Revisiting Nomenclature - 200GBASE-FR1 (Support of Comment #311)

**IEEE P802.3dj Task Force
IEEE 802.3 May 2024 Session**

Figure 182–1—200GBASE-FR1, 400GBASE-DR2-2, 800GBASE-DR4-2, and 1.6TBASE-DR8-2 PMD relationship to the ISO/IEC Open Systems Interconnection (OSI) reference model and IEEE 802.3 Ethernet model

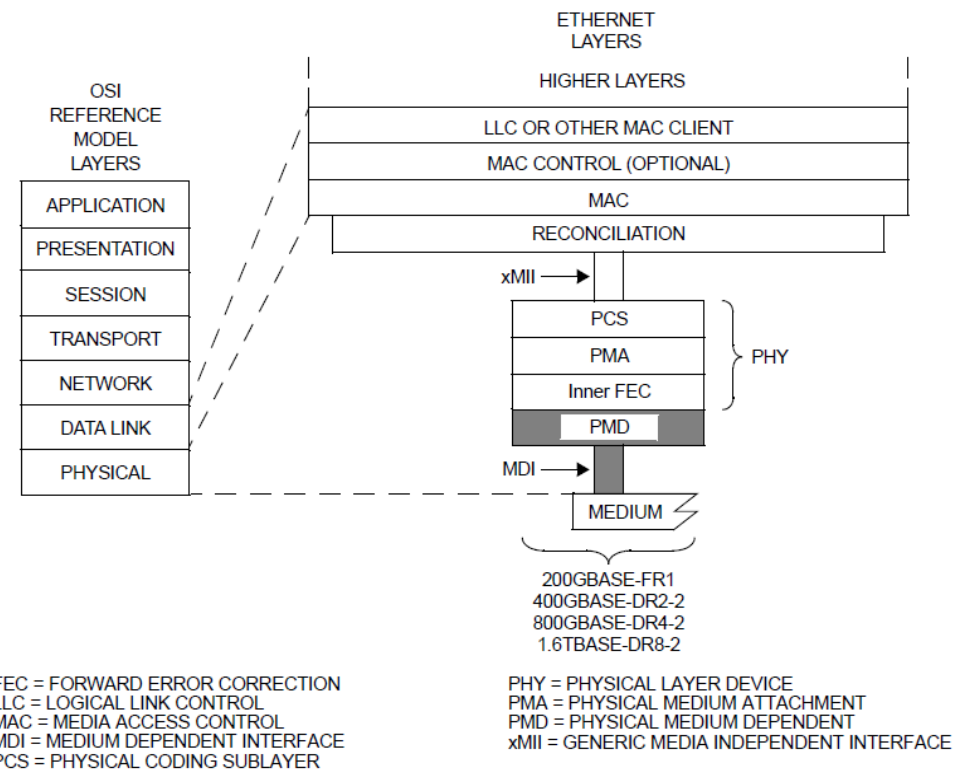
182. Physical Medium Dependent (PMD) sublayer and medium, type 200GBASE-FR1, 400GBASE-DR2-2, 800GBASE-DR4-2, and 1.6TBASE-DR8-2

- **Adding a “Reach” suffix in nomenclature is now common**
 - **DRx and DRx-2**
 - **FR4 and FR4-500**
- **With the adoption of 800GBASE -FR4-500 the originally adopted nomenclature for the 500m/2km objectives is not consistent**
- **IEEE P802.3dj D1.0 aligns 200GBASE-FR1 with the “-DR” family – not the “FR” family.**
- **Recommendation - Rename 200GBASE-FR1 to 200GBASE-DR1-2**

Proposed Remedy: Rename 200GBASE-FR1 to 200GBASE-DR1-2
